City of Surrey PLANNING & DEVELOPMENT REPORT Application No.: 7919-0123-00

Planning Report Date: June 14, 2021

- OCP Amendment from Urban to Multiple Residential
- NCP Amendment from Single Family / Duplex o.6 FAR to Residential Low to Mid Rise up to 2.5 FAR and to adjust the alignment of the east/west road
- **Rezoning** from RF to CD (based on RM-70)
- Development Permit

to permit the development of two 6-storey apartment buildings in City Centre.

ELEVATIONS & MATERIAL BOARD

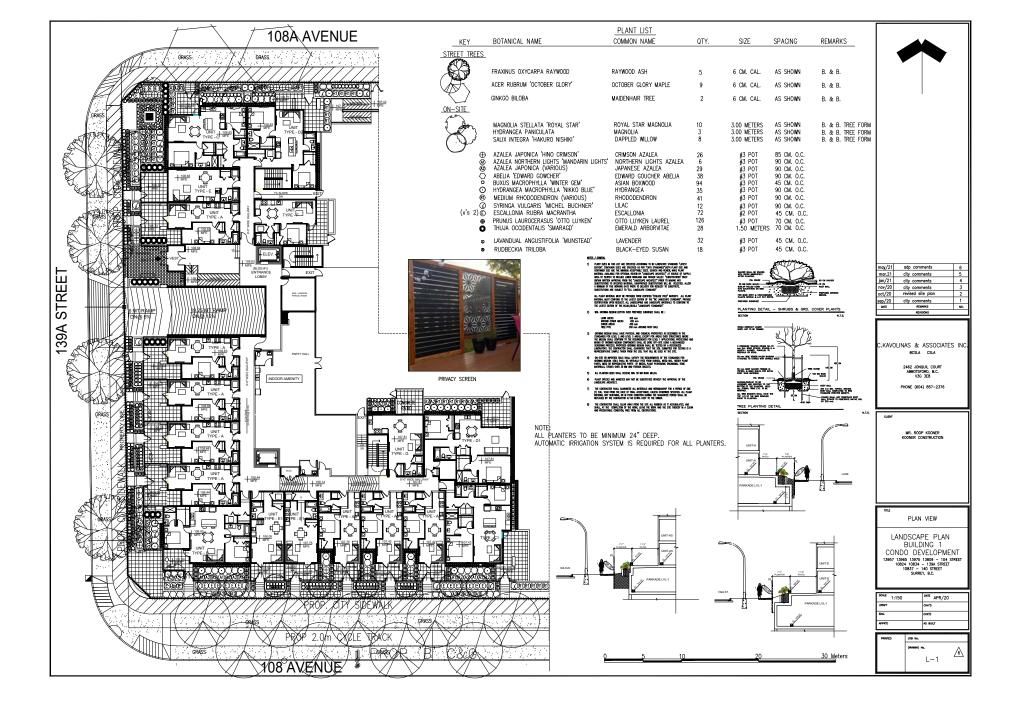
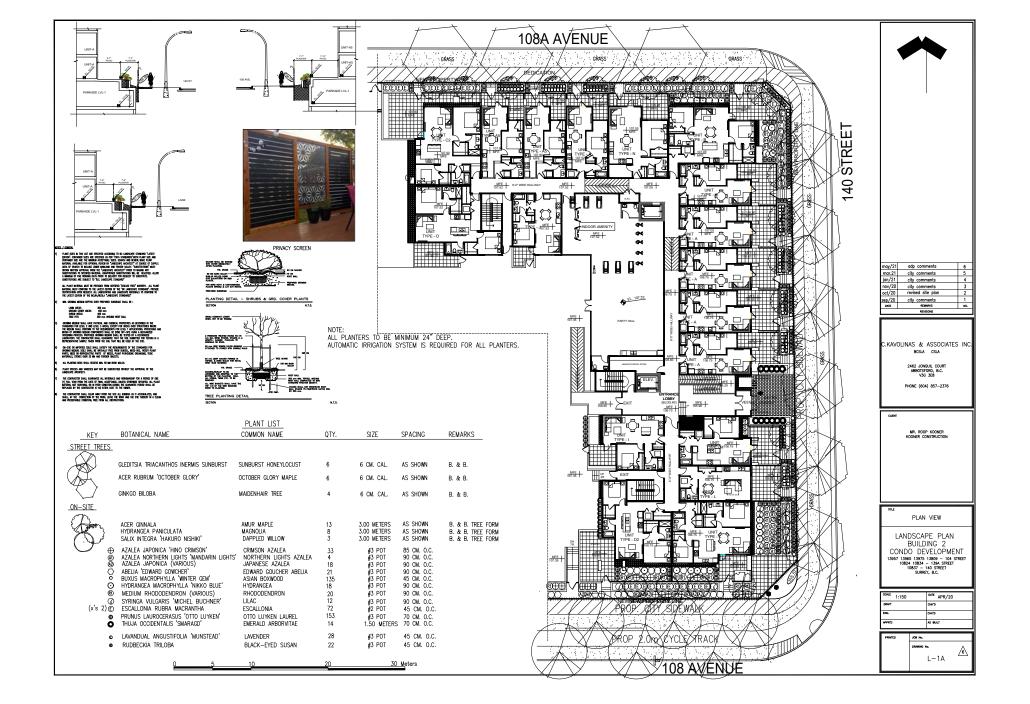
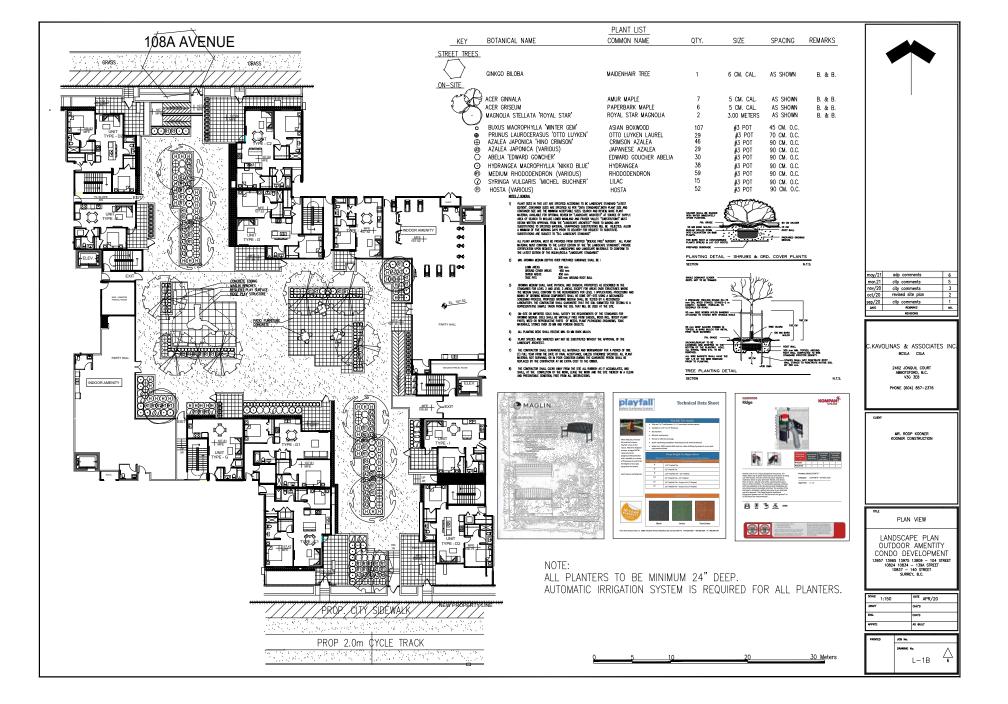
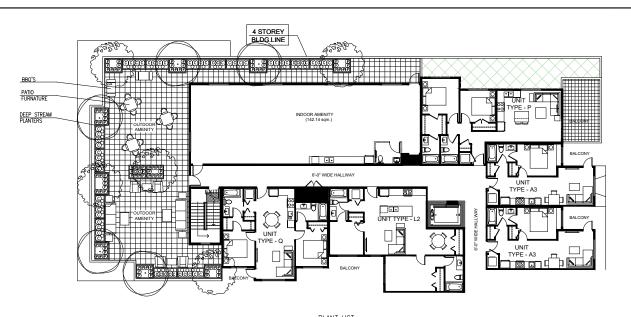
- rotated to provided direct access from lobby to the courtyard for both buildings. See page A-100 site plan, Page A-202 to A-206 floor plans.)
- Consider simplifying the architectural expression; the design might benefit from a bolder use of brick.

- (noted, brick material are used on the main floor façade facing street on both buildings to create a simplify architectural expression. See page A-320 to A-327.)
- Consider revisiting the final finish elevation on the main floor of the buildings.
 - (noted, all final finish elevation on the main floor of the building are design as per city's comments of 0.6m to 1.2m above the adjacent side walk. See page A-100 site plan.)
- Consider relocating some of the indoor amenity space to facilitate a larger outdoor amenity.
 - (noted, indoor amenity space in the courtyard has been eliminated and additional indoor amenity space has been added to 5th floor of both building 1 and building 2 to create a larger outdoor amenity in the courtyard. See page A-100 site plan, page A-202 main floor plan, and page A-205 fifth floor plan building 1 & 2.)

OCP Amendment 19-0123-00

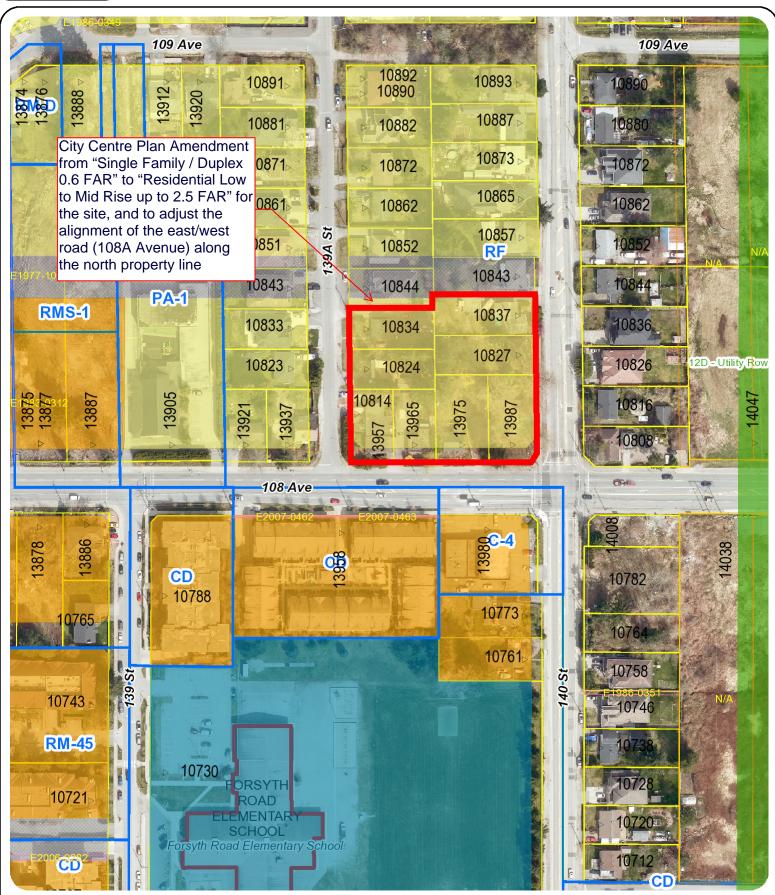
• The subject site is designated "Urban" in the Official Community Plan (OCP). The proposed development does not comply with the OCP. Therefore, the applicant has proposed an OCP Amendment to redesignate the subject site from "Urban" to "Multiple Residential" (see Appendix V).

City Centre Plan Amendment

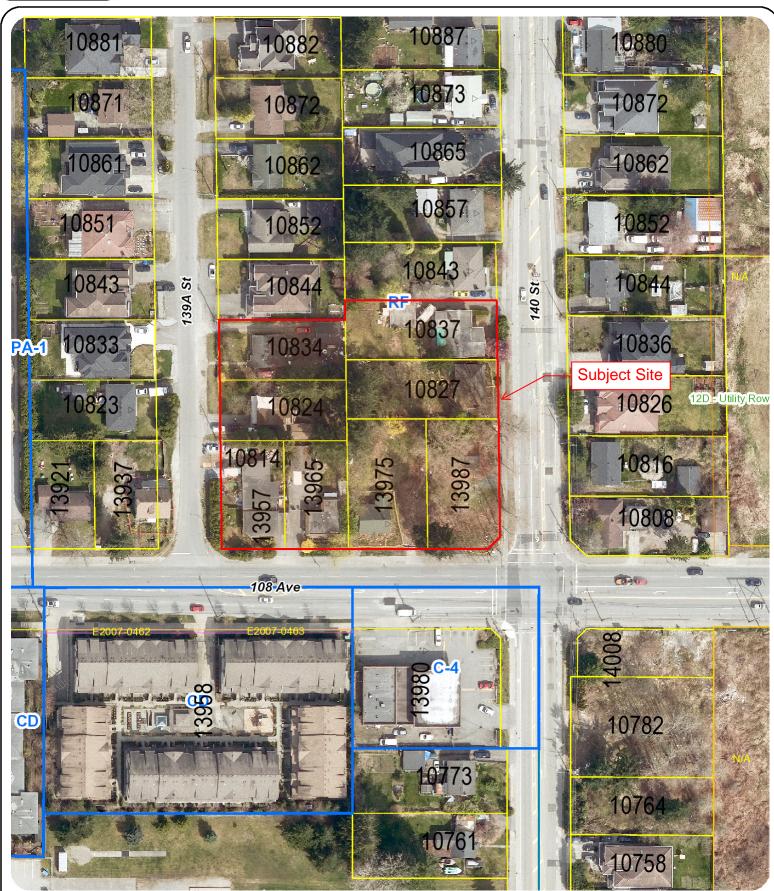
- The subject site is designated "Single Family/Duplex o.6 FAR" in the City Centre Plan (CCP).
- The proposed development, which proposes a gross FAR of 2.5 (2.9 net FAR), does not comply with the CCP land designation. Therefore, the applicant has proposed a CCP Amendment to redesignate the subject site from "Single Family/Duplex o.6 FAR" to "Residential Low to Mid Rise up to 2.5 FAR". A minor adjustment to the alignment of the east/west road along the north property line is also proposed (see Appendix VI).

- As part of the City Centre Plan Amendment, the applicant also proposes a minor re-alignment of the new east/west road. The City's Transportation Engineering Section has reviewed the proposed adjustment as part of the subject development application, and generally support the slight realignment.
